CRIME IMPACT STATEMENT

BRUNSWICK STREET, ARDWICK, MANCHESTER
RESIDENTIAL (16 no. APARTMENTS)

VERSION A: 14/04/2021

REFERENCE: 2016/1003/CIS/02

1 Visual Audit

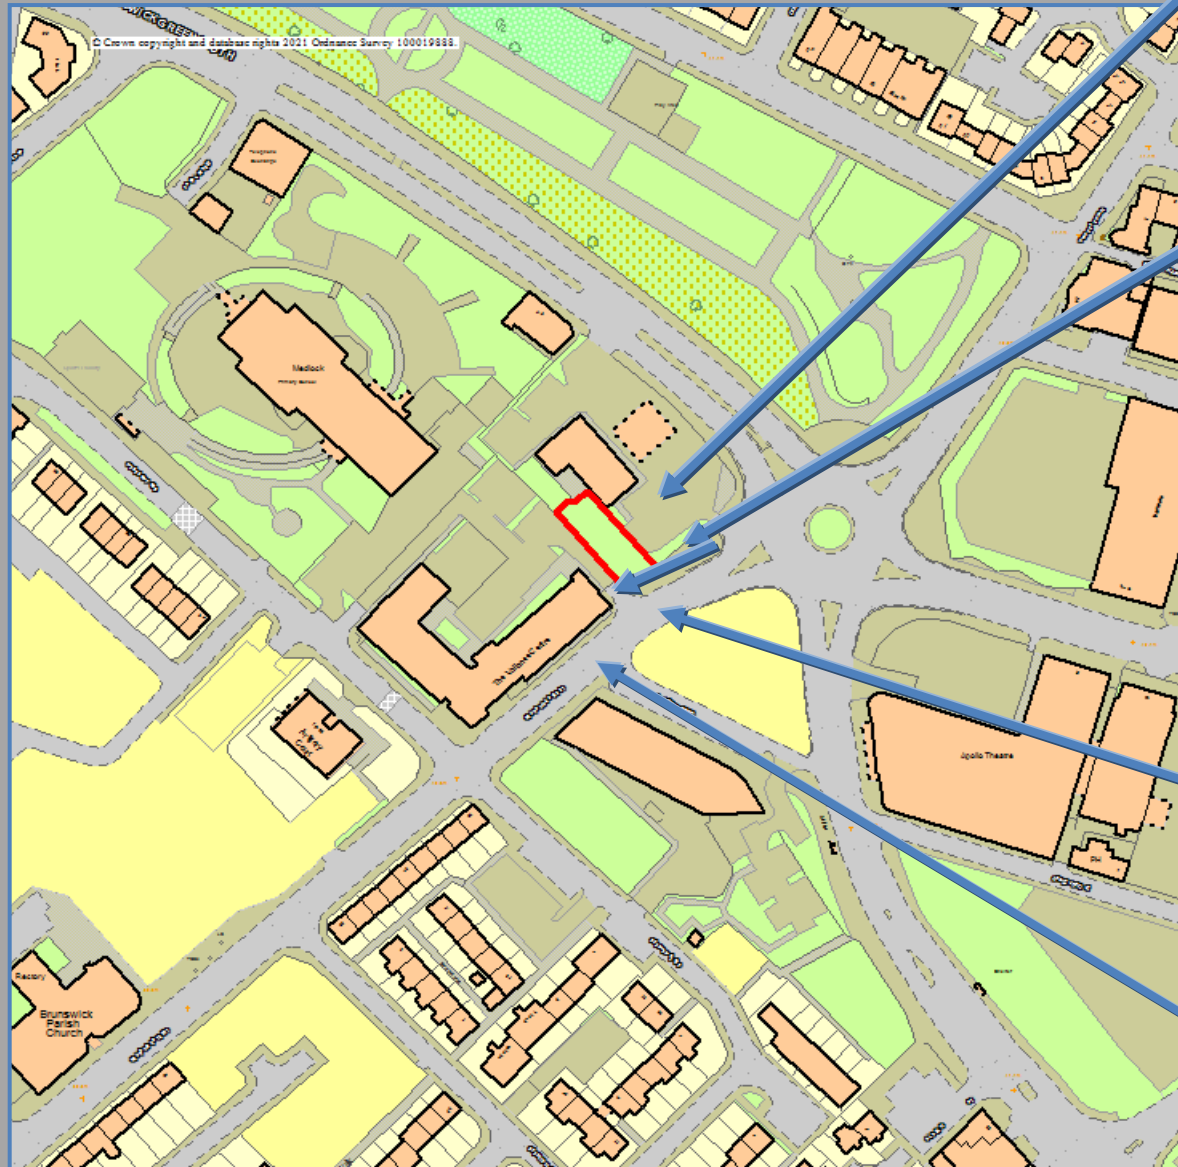
The petrol station to the immediate north-east is separated from the site by a high wall. The petrol station/store building lies towards the rear of the site, with a parking area along the majority of the boundary. Low walls, an adjacent tree and parked vehicles themselves could provide aids to climbing over the boundary into the site.

To the south-west of the site is the Vallance NHS Centre – a medical centre offering a number of GP services and clinics. Between the building and the site itself is an access road serving the staff car park at the rear of the building. The access road is fitted with access-controlled pedestrian and vehicular gates that were operational at the time the site visit was carried out, but remained open for long periods of time after operating – leaving the hidden rear elevations of the building, parked vehicles and the south-eastern elevation of the site potentially accessible and vulnerable.
